Environmental Review Team Report

Boline Property

Lyme, Connecticut

January 1980

Vegetation Type Descriptions

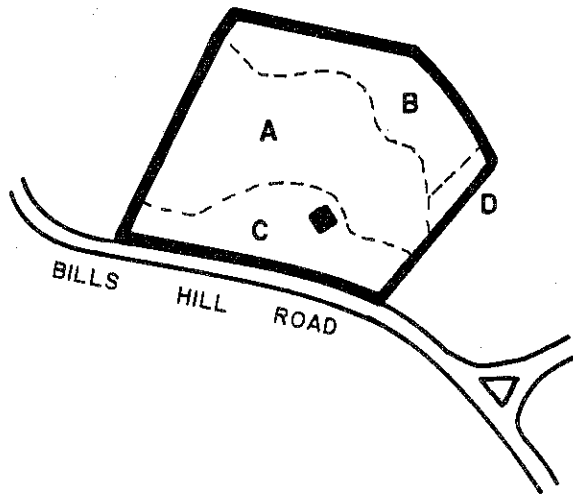
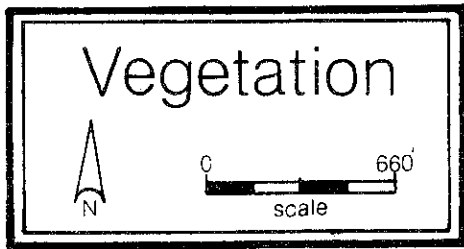
Windthrow is a potential hazard in the hardwood swamp (vegetation type A). As a result of the high water table and saturated soils, the trees present are shallow rooted and unable to become securely anchored. The crowded condition of the trees in this stand increase the potential for windthrow if disturbances occur. At present these trees rely on each other for stability. If linear openings are made in, or along side, this stand, the windthrow hazard may be increased. Any openings which would allow wind to pass through rather than over this stand will increase the windthrow hazard and should be avoided. A light fuelwood thinning in this stand will help to increase tree stability over time, by stimulating crown and root growth in residual trees.

The dense growth of cat-brier located in vegetation type B is a potential hazard to future lot owners. The thorny nature of this vegetation restricts the use and therefore the enjoyment received from the property. Cat-brier also has the capacity to lower the quality of the supporting vegetation through intense competition. Control of the unwanted cat-brier is difficult. Mechanical control in conjunction with the cautious application of herbicides has proven to be the most effective method of eradication.

The trees in the hardwood swamp (type A) and mixed hardwood stand (type B) are over crowded. As a result they are declining in health, vigor and stability. A fuelwood thinning in these stands will reduce competition between residual trees for sunlight, space, and nutrients. These thinnings will stimulate growth and increase tree stability over time.

The thinning in the hardwood swamp should remove no more than one-fourth of the total volume. This will be approximately 3 cords per acre. This thinning should focus on removing very poor quality trees and damaged trees. It should also favor species other than red maple. Harvesting operations should be restricted to months when the ground is frozen or months when the ground is dry to avoid severe environmental damage.

The thinning suggested for the mixed hardwood stand (type B) should follow the "Crop tree selection method". For the purposes of this thinning, 100 of the highest quality trees in each acre should be identified (trees spaced about 20' x 20' will equal 100 trees per acre), and one, two, or three trees that are in direct competition with each of those identified should be removed. The 100 trees per acre that are selected as crop trees should be healthy, large crowned, and show little or no signs of damage. Trees which are not competing with the 100 selected trees should not be removed, unless they are severely damaged. This thinning, if implemented, will provide between 4 and 6 cords of fuelwood per acre.
